**RENOVATION OF THE KHANDEK
INTERMEDIATE SCHOOL
UNDER THE ECONOMIC SUPPORT FUND PROGRAM
YOUSEFIYA, IRAQ**

SUSTAINMENT ASSESSMENT

**SIGIR PA-08-136
APRIL 21, 2009**

Figure 2. Septic tank section (Courtesy of GRC)

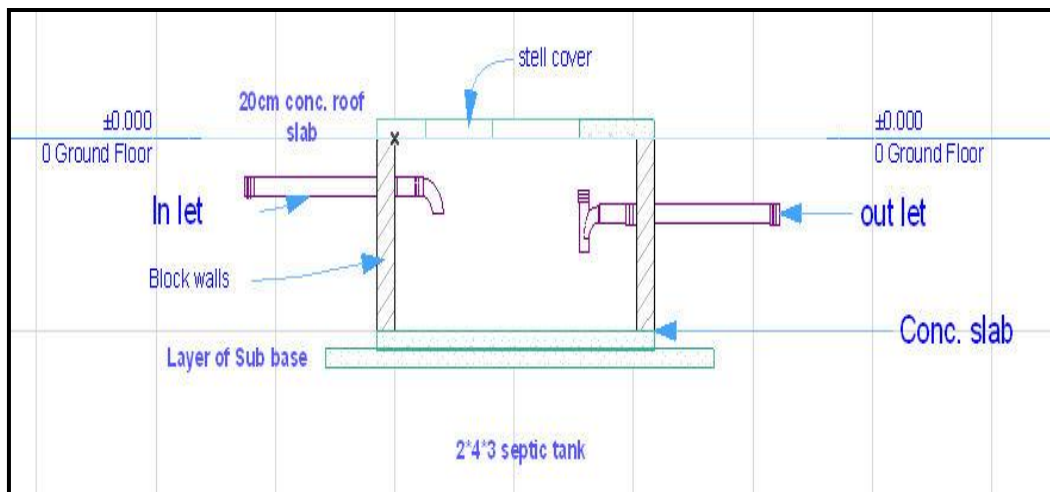
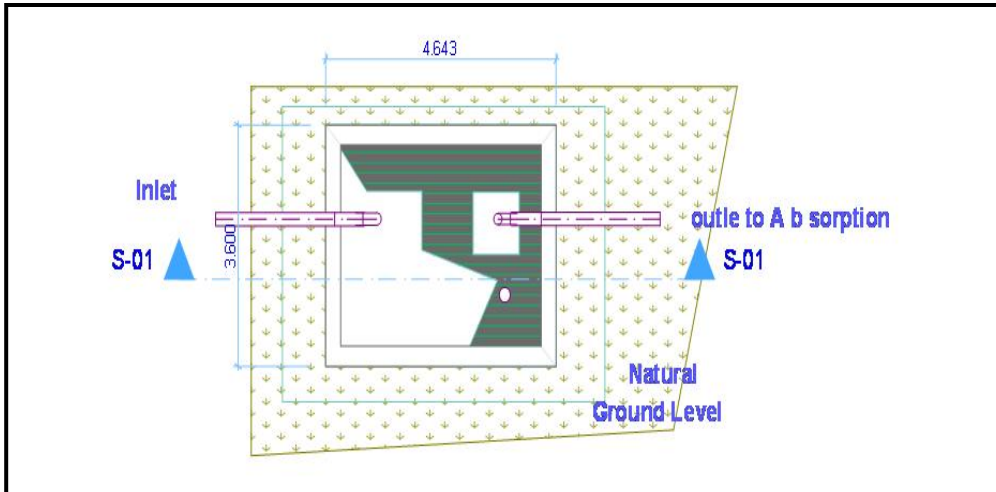
The septic holding tank indicates that the outlet of the tank flows to an absorption area. The location and configuration of the absorption was not indicated in the design. It is unclear if this system is intended to treat sewage and promote absorption into the soil, or if the tank(s) function as holding tanks to be pumped out on a regular basis.

Site Photo 6. Missing window screen

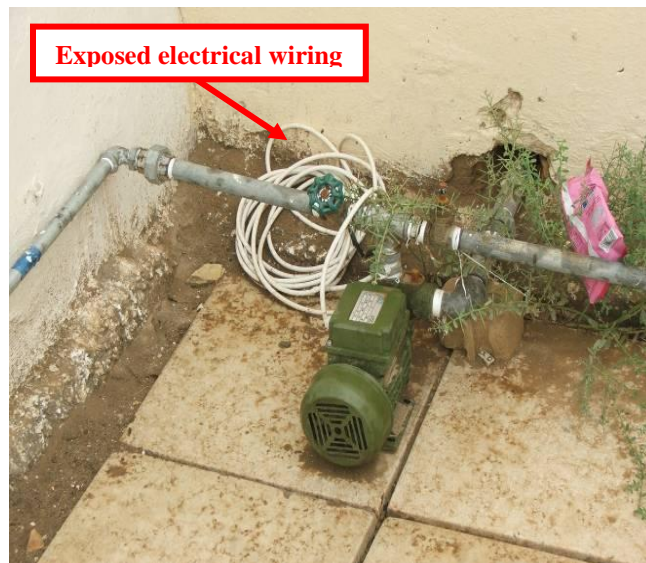
The new steel exterior doors and hardware were installed and functioning. The window glazing appeared to be in-tact. The windows have been painted and latching hardware has been installed. SIGIR did not observe any of the BOQ required window screens (Site Photo 6).

Site Photo 8. New latrine building with significant shear crack

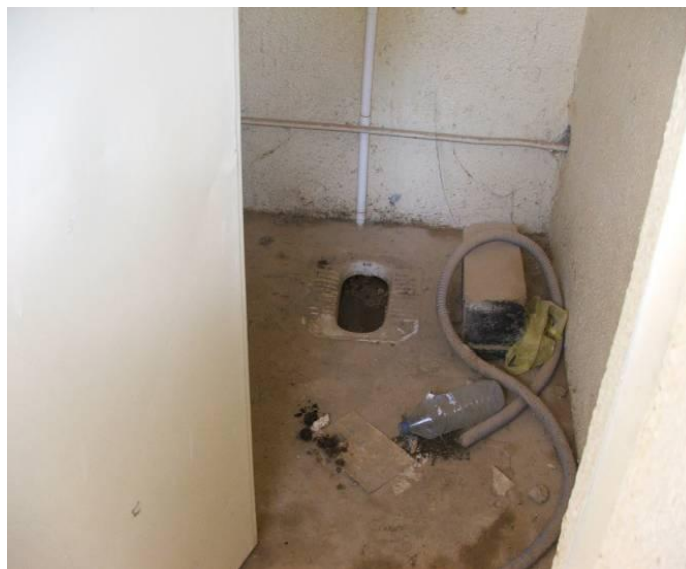
A new septic tank was constructed along with the new latrine. SIGIR identified a significant shear crack in the main beam along the front edge of the roof on the new latrine building (Site Photo 8).

Site Photo 9. Condition of the eastern-style toilet

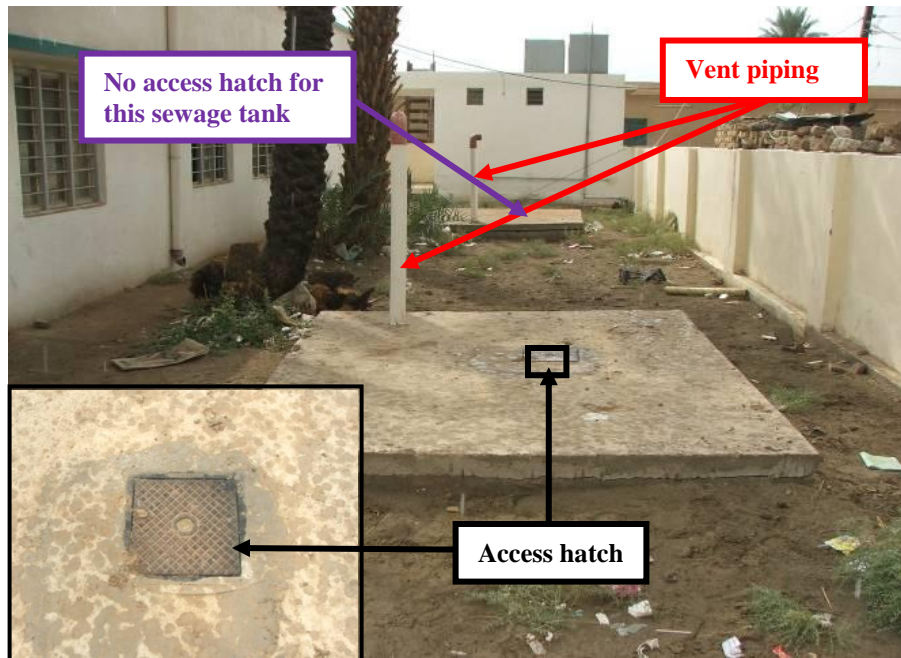
The restrooms in both latrines contained eastern-style toilets (Site Photo 9) with wall hung water tanks. At the time of the site visit, water service was not available to either latrine building; therefore, SIGIR could not verify the operability of the plumbing fixtures. Even though water was not available, the toilets were still being used. This resulted in blockages to the sanitary sewer and standing water in the toilets, resulting in unsanitary conditions for the school children.

Site Photo 10. Septic holding tanks and tank access for one (lower left corner)

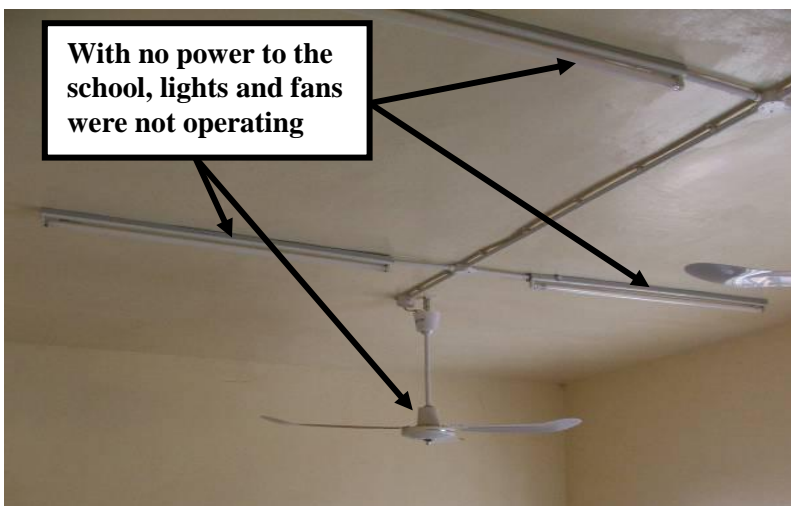
Two septic tanks were constructed on the site to service the two latrines (Site Photo 10). Vent piping was installed in the top slab of the tanks. SIGIR examined the tanks' top slabs, which did not exhibit any cracking or signs of failure; however, there was moderate curling of the top slab. A small access was provided for one of the tanks, which could be used for inspection and pumping; however, there was no access provided for the second tank. SIGIR believes this presents the school with future maintenance problems, since the school will be unable to fully empty the tank and residue will accumulate at the tank's bottom.

Figure 4. Contractor’s site plan submittal clearly showing the construction of a new water closet (latrine building) (Courtesy of GRC)

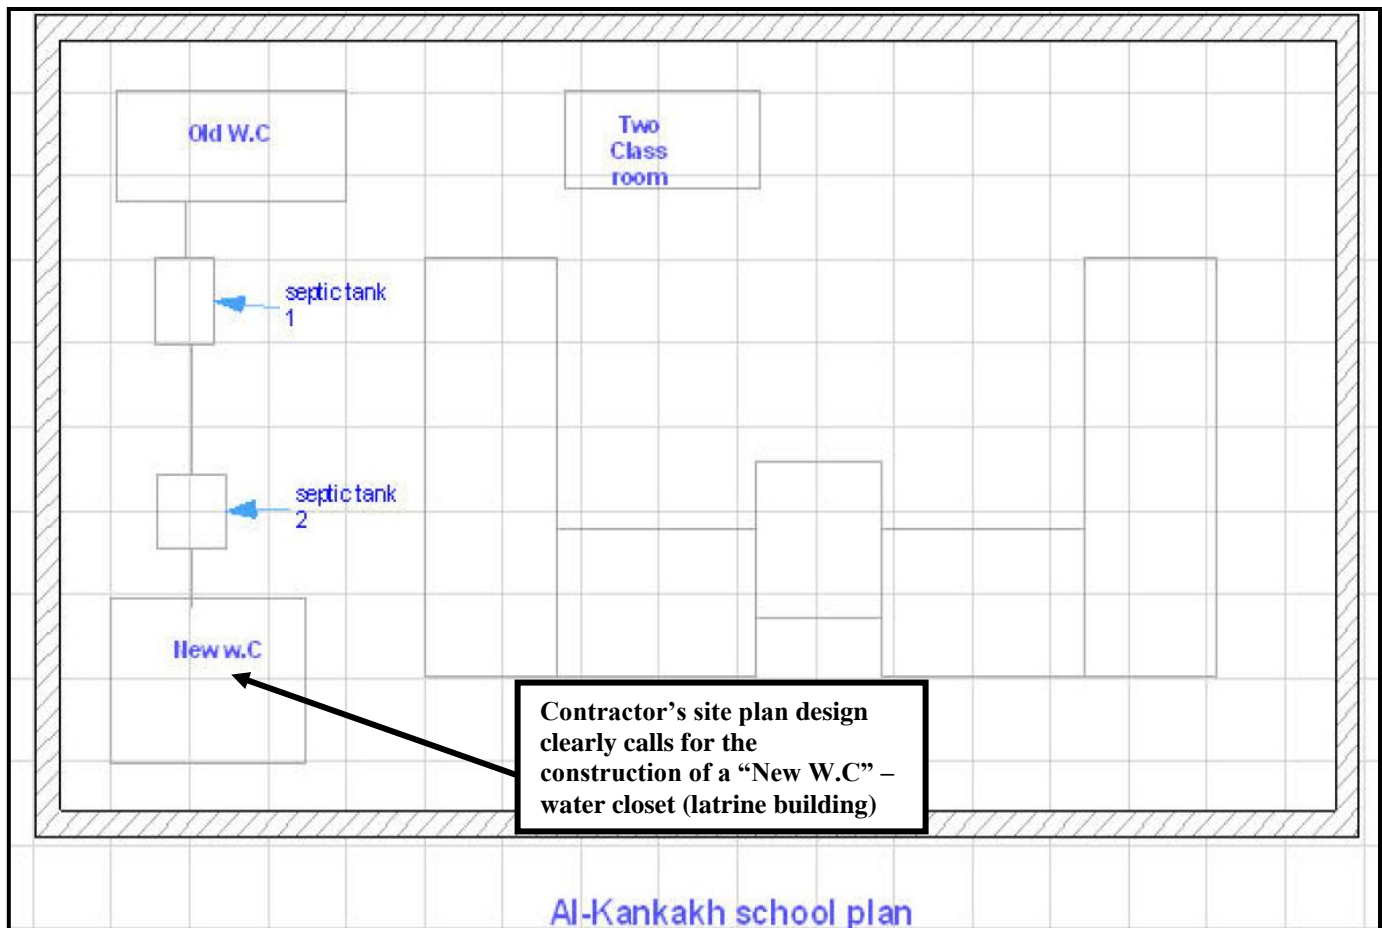
However, this statement is contradicted by the contractor's design submittals, which clearly indicated on the school's site plan “New W.C. [water closet]” (Figure 4). The design, which the contractor submitted to GRC for review and approval prior to construction, refutes the statement that this water closet/latrine building was the idea of the school master and not part of this contract.
